Product Discontinuation Notice

Solid State Relay

No.ICDRY-080040

Solid State Relays (Single-phase) G3PB series

(Relevant model : G3PB-215B/225B/515B/-VD)

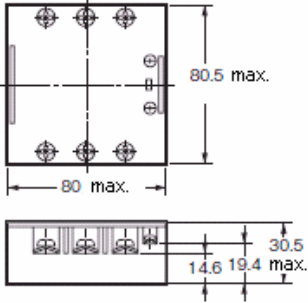
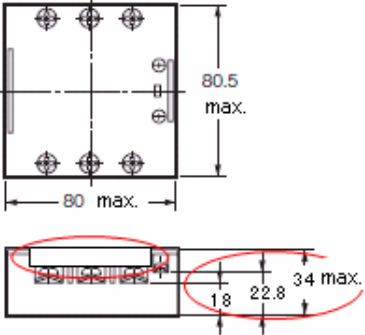
Product discontinuation	Recommended replacement
	<p data-bbox="1105 722 1446 789">Note : The change of terminal cover to improve finger protection.</p>

(Relevant model : G3PB-2□□B-2(H)(N)-VD、G3PB-2□□B-3(H)(N)-VD、
G3PB-4□□B-2(H)-VD、G3PB-4□□B-3(H)-VD
G3PB-5□□B-2(H)(N)-VD and G3PB-5□□B-3(H)(N)-VD)

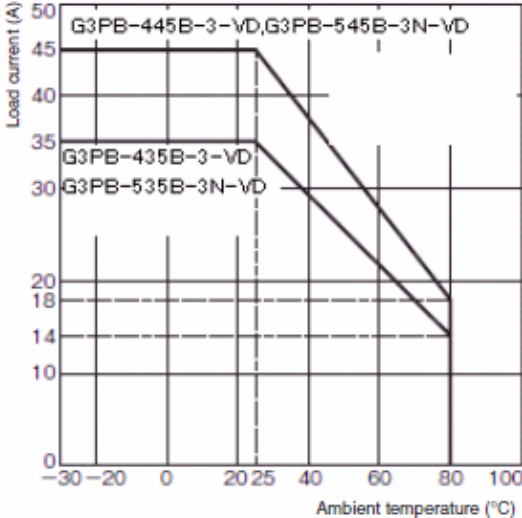
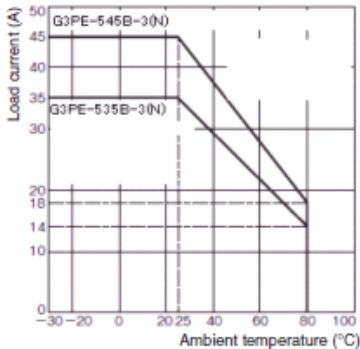
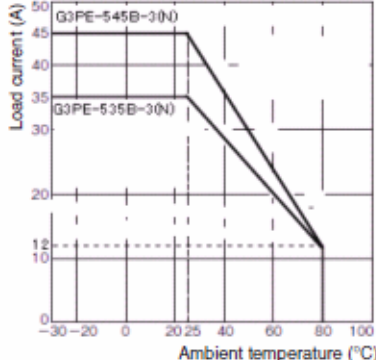
Product discontinuation	Recommended replacement
	 <p>Note 1) The change of terminal cover to improve finger protection. 2) Height change</p>
<p>Size of heat-sink is the same</p>
